MANISTEE CITY PLANNING COMMISSION

MEETING OF JULY 1, 1999

Staff Report

Lighthouse Landings L.L.C.

SUBJECT: Lighthouse Landings

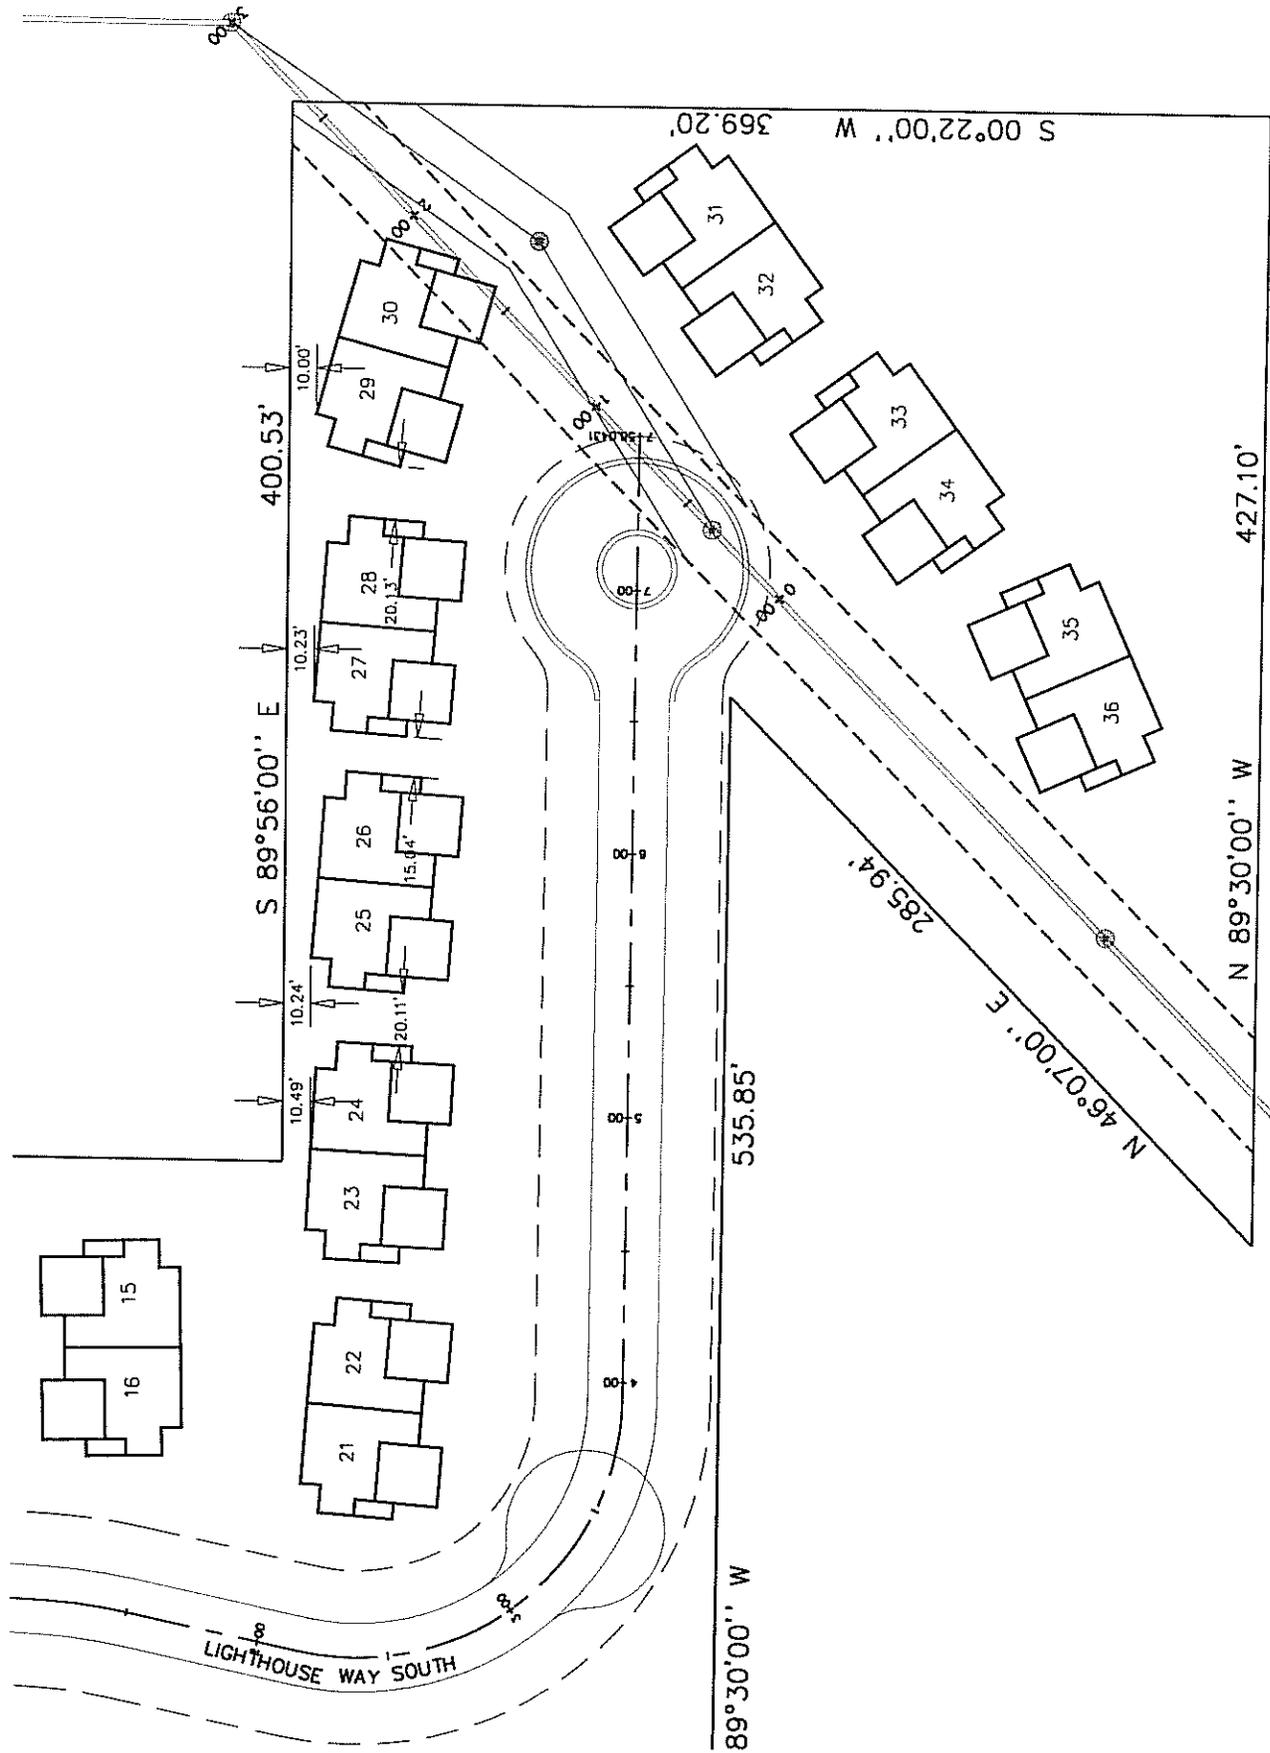
The plans I reviewed showed three structures located on the South side of a drive that extends approximately 120 feet west from the south cul - de - sac. The building farthest to the west is too far from Lighthouse Way, South to allow adequate Fire Department access.

I would find the development as planned unacceptable. I would find the development as mapped acceptable if one of the following were done:

1. Delete the structure (units # 35 and # 36) on the west end of the drive from the plan.
2. Increase the radius of the cul - de - sac to a minimum of 45 feet. This must be measured to the inside of the curb.
